# **OFFICIAL MEETING NOTICE**

1. Call to Order
2. Elect Business Park North Chair and Vice-Chair
3. CHC Properties LLC requests site plan approval to construct a building at 201 Business Park Circle.
4. Future agenda items.
5. Adjournment.

**Item #3 – CHC Properties LLC requests site plan approval to construct a building at 201 Business Park Circle.**

I have completed a preliminary review of the proposed building site plan for Keith Comstock, 201 Business Park Circle, Stoughton, WI. 53589 – plans received 5/7/14. As noted, additional information may be required to be provided or shown on the plan.

Site Plan  
Scale = 1" = 20'-0"

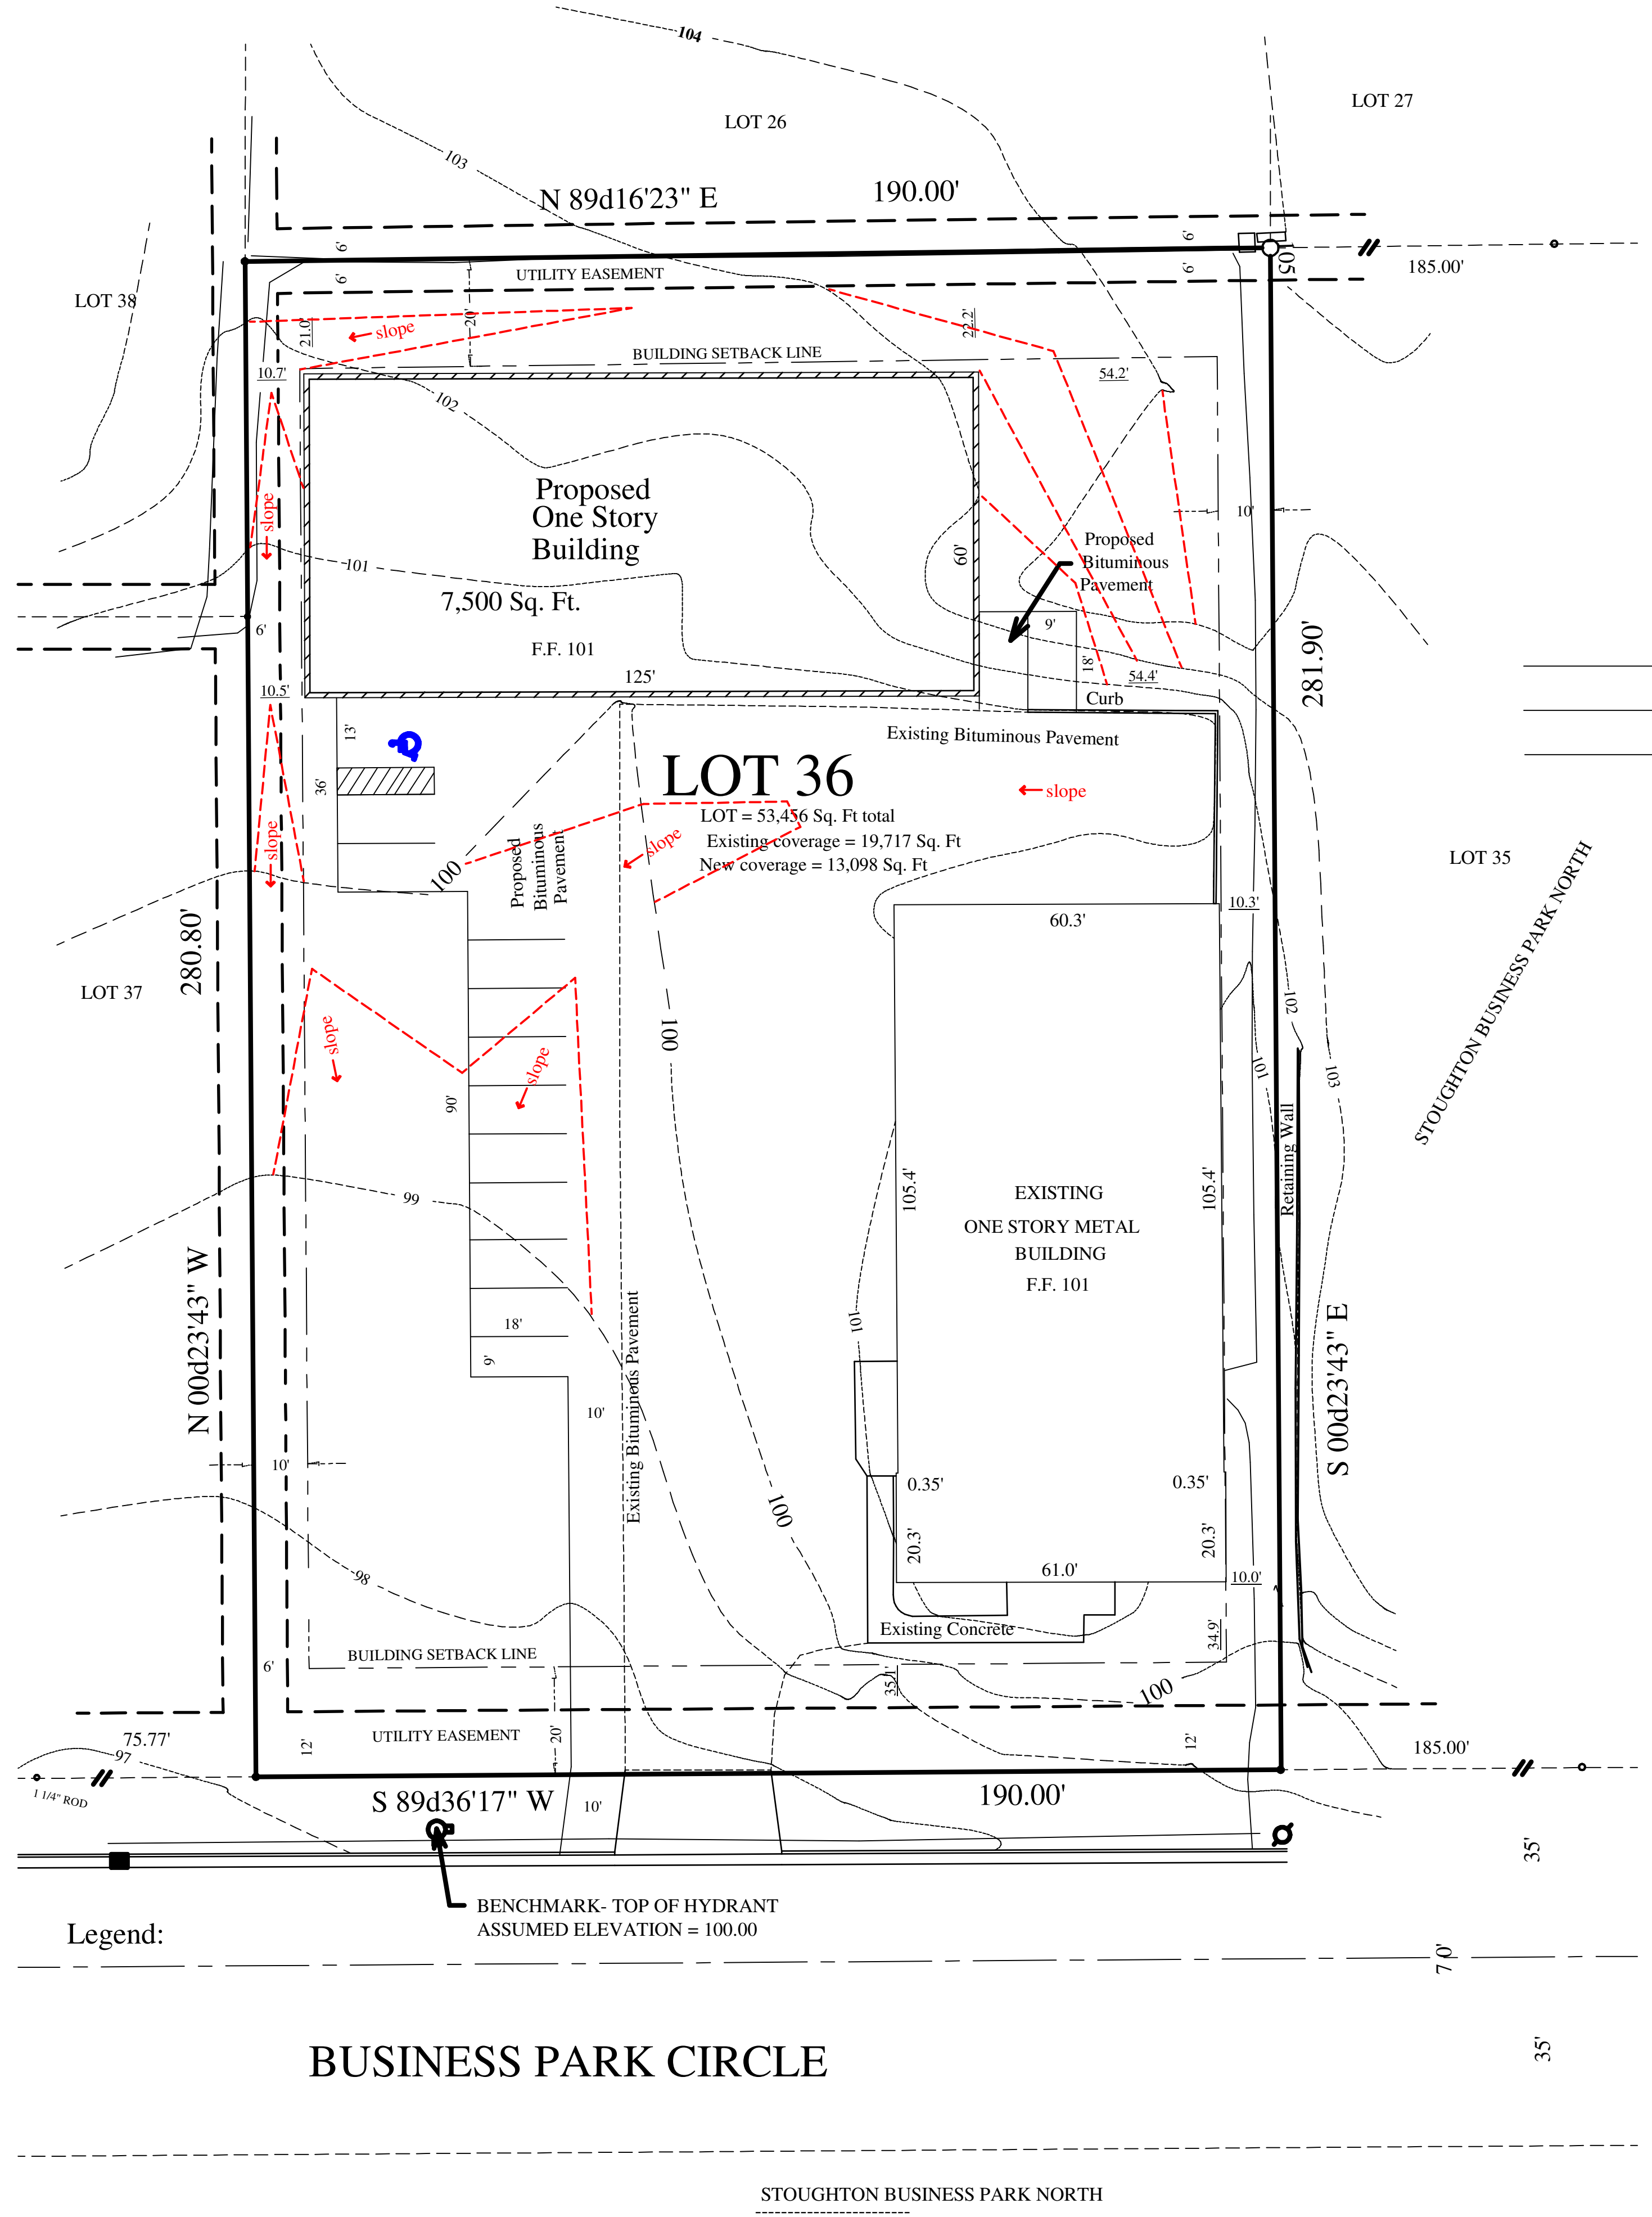
5. The proposed building minimum setback and maximum height requirements are as follows: Front yard setback: 20 feet; Side yard setback: 10 feet; Rear yard setback: 20 feet; Maximum building height: 40 feet; Minimum building separation: 20 feet. **The plan meets these requirements. Due to the proximity of the building to the minimum setbacks, a survey will need to be provided to confirm building location.**

15. All curb openings for access drives shall have a maximum width of 30 feet for non-residential uses, as measured at the right-of-way line. Access drives may be flared between the right-of-way line and the roadway up to a maximum of five additional feet and may be exceeded with explicit Plan Commission approval. **It appears the access drive is proposed to be widened to approx. 37 feet at the right-of-way line and 42 feet at the curb. The Planning Commission will need to approve this additional width.**

18. Off-street loading stall requirements per section 78-705. **If deliveries from large trucks are anticipated, one off-street loading stall will need to be shown per section 78-705. If van-type trucks are anticipated (not semi-trucks), a diagram shall be provided detailing how the truck will be able to maneuver onsite. Backing into the street is not allowed.**

24. All exterior trash storage areas shall be located within a gated enclosure which completely screens the view a said trash. The exterior of said enclosure shall be constructed of some or all of the materials used on the main building. **There is no enclosure shown/planned.**

Project: **New Building**  
Address: Stoughton, WI  
Sheet Title: **Plans and Elevations**

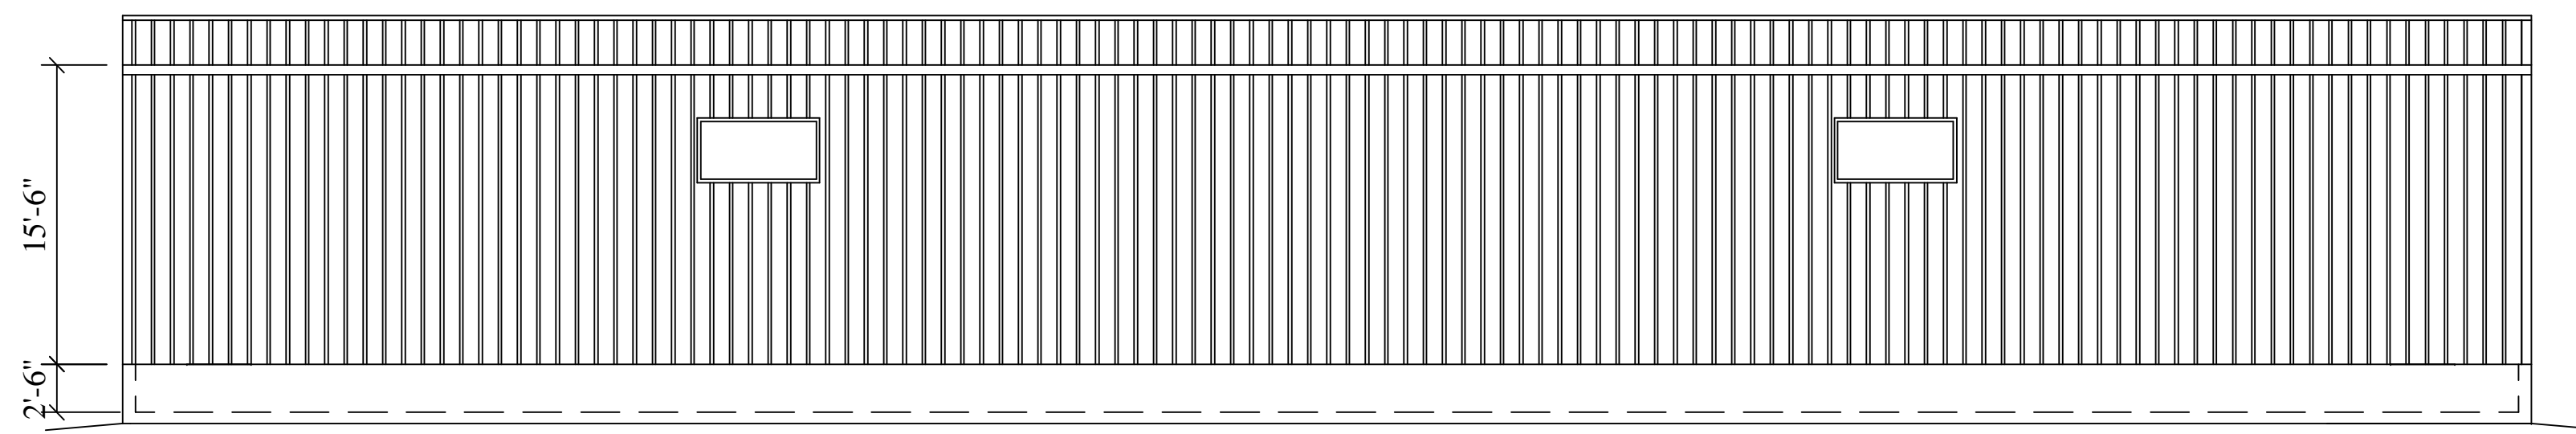
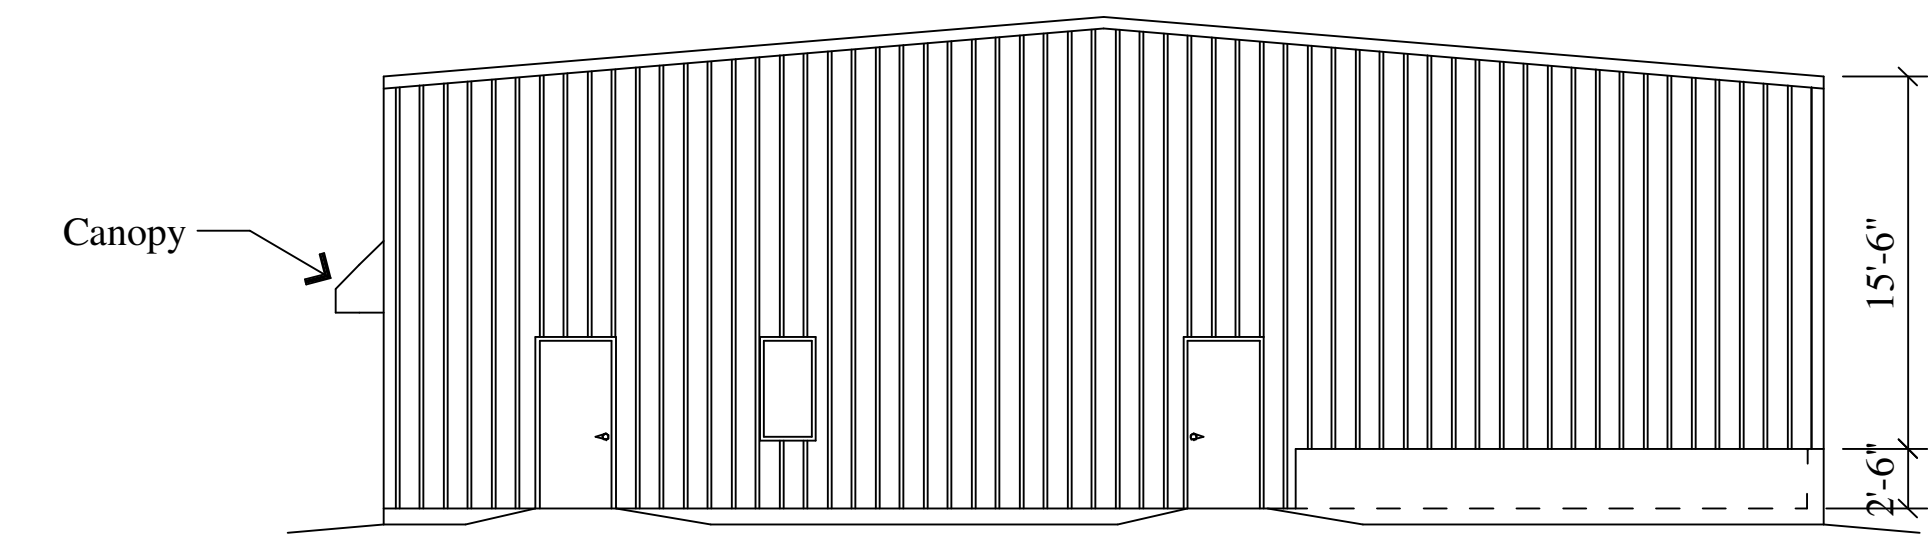
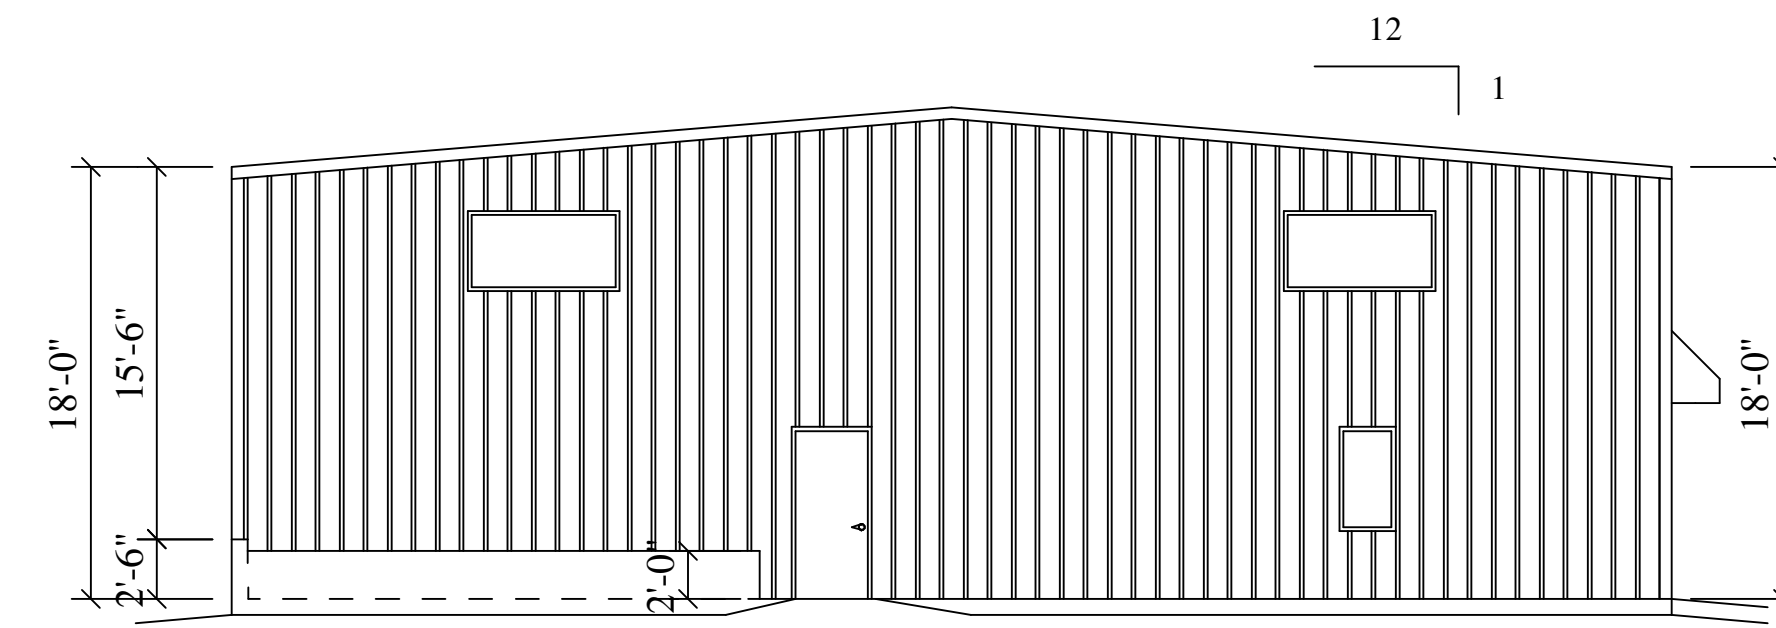
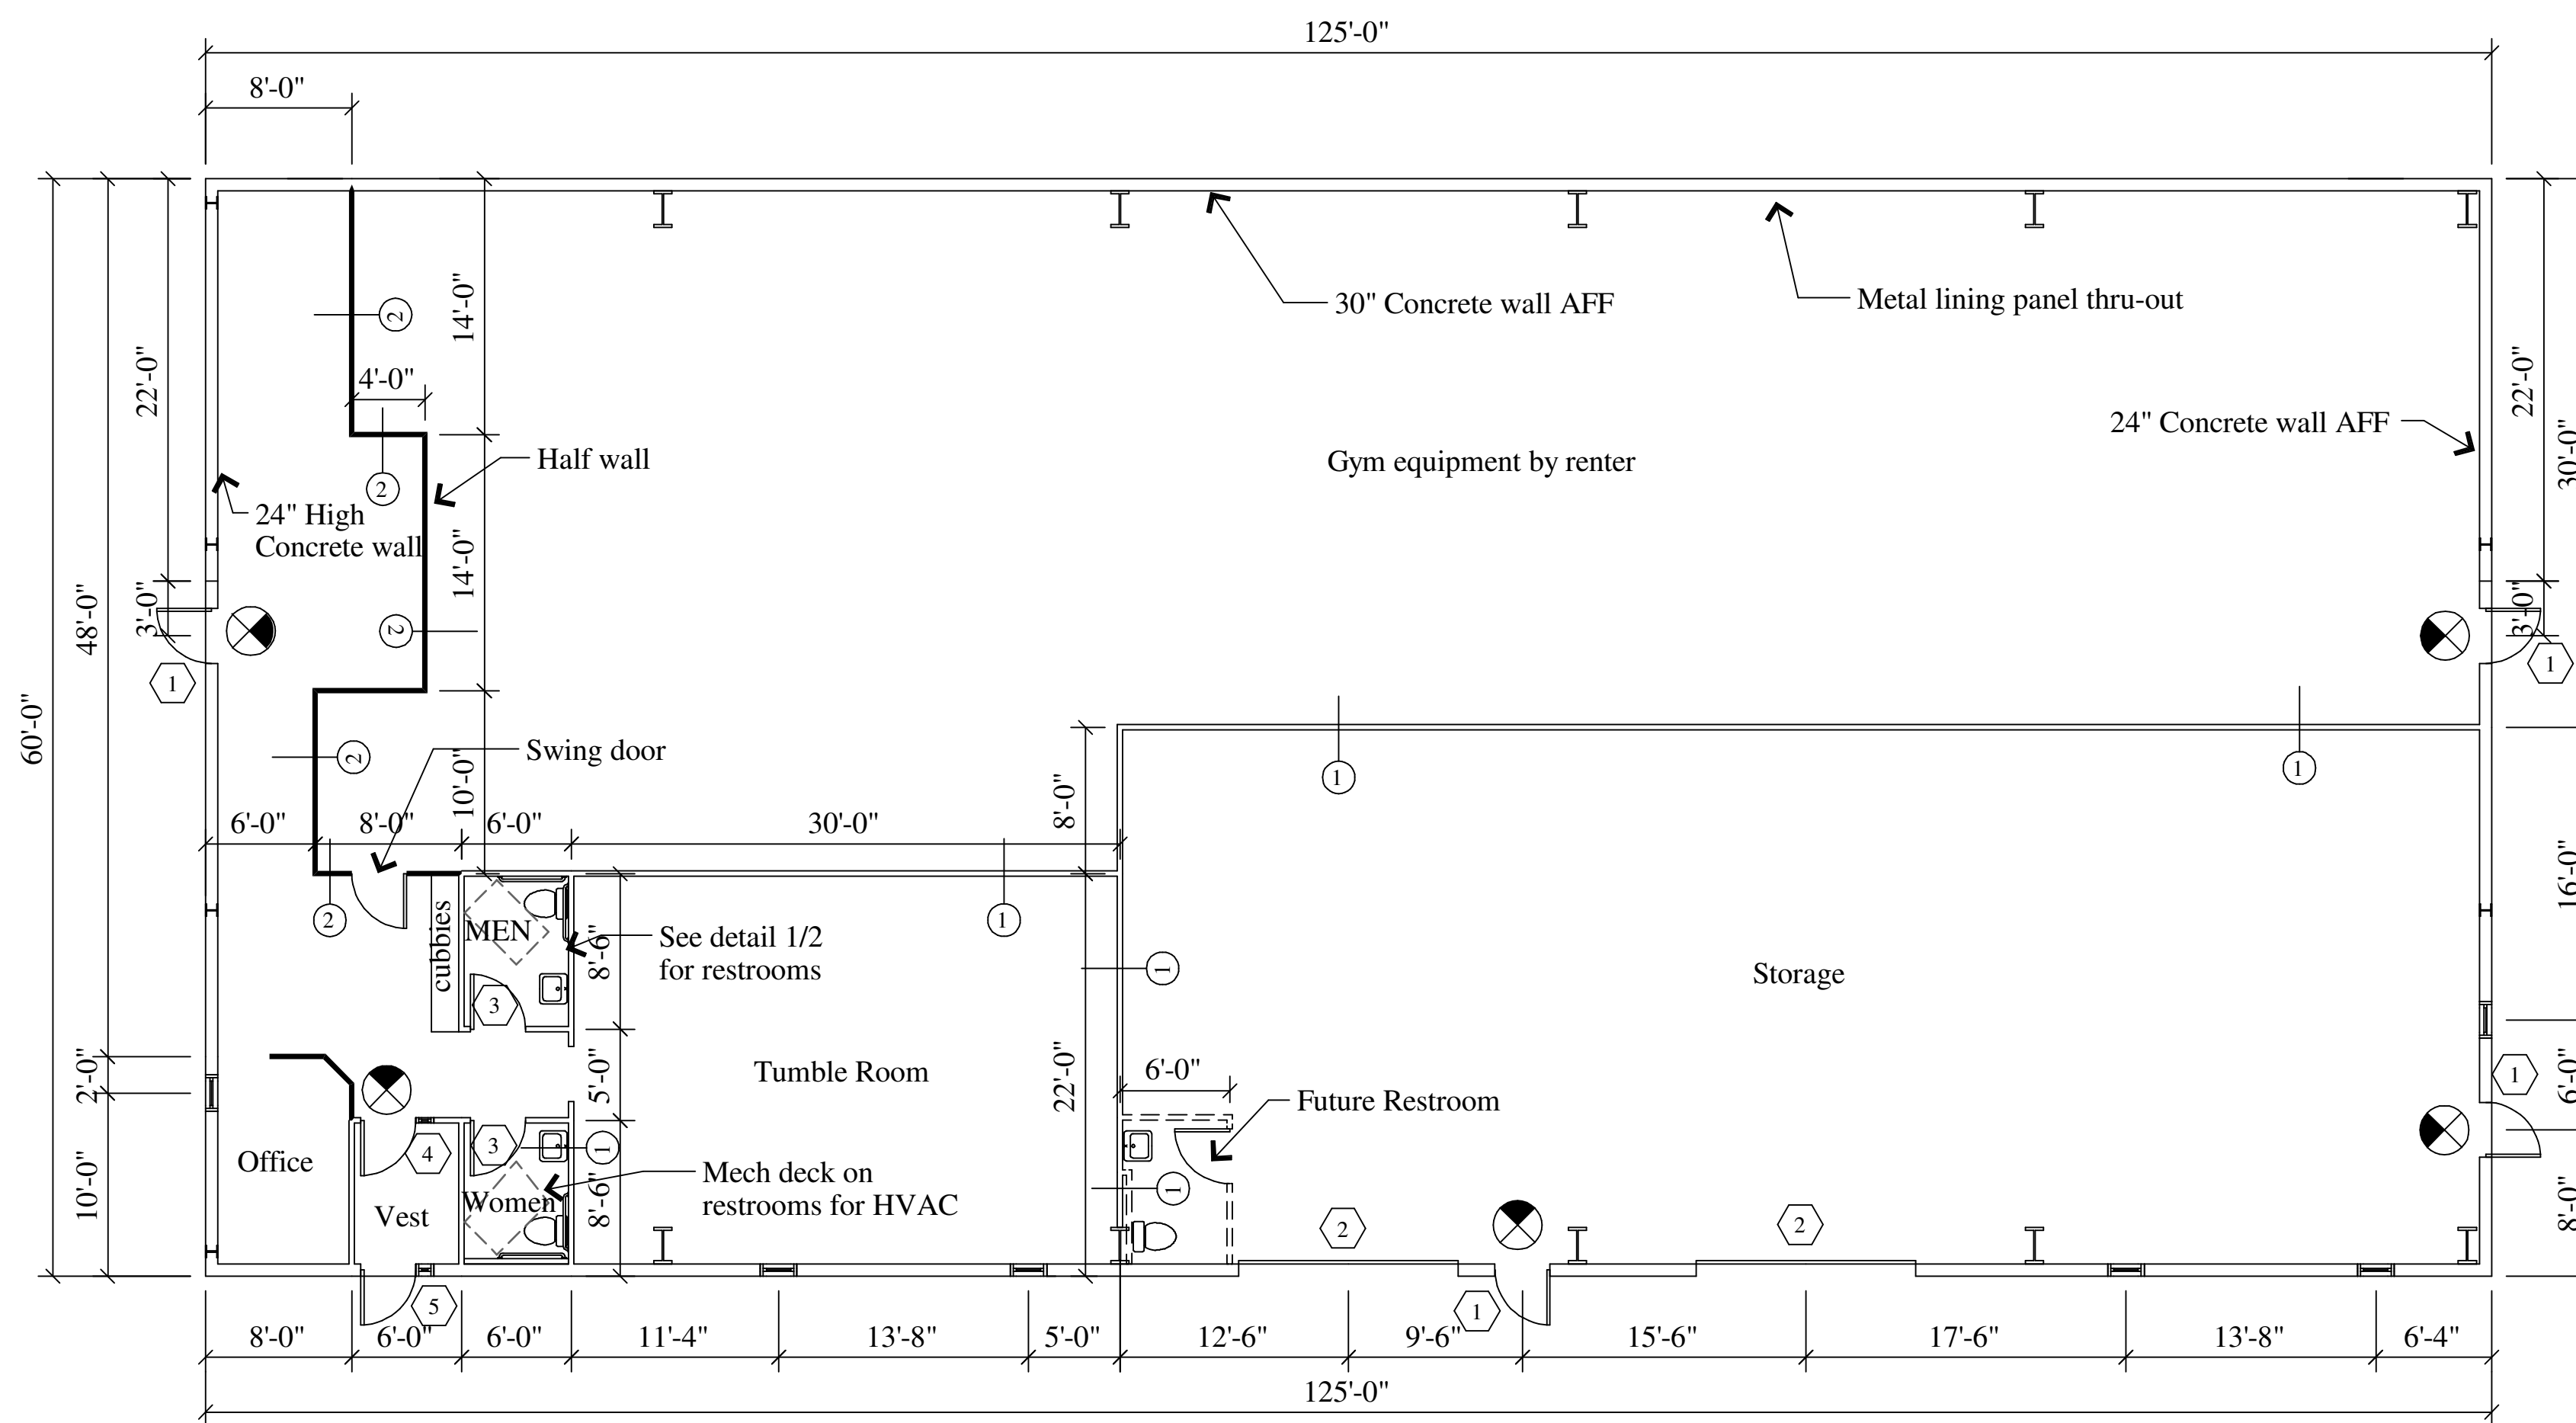
20. Architectural and design elements shall be compatible with the surrounding area and community standards and shall minimize user specific elements as determined by the plan commission. Metal panels with exposed exterior fasteners of the same color may be used on a maximum of 50 percent of the front side of the building. This material is not allowed within 50 feet of any customer or visitor entrance. **This will be determined by the Planning Commission.**

**The summary letter describes the proposed structure is to use the same exterior materials as the existing structure.**
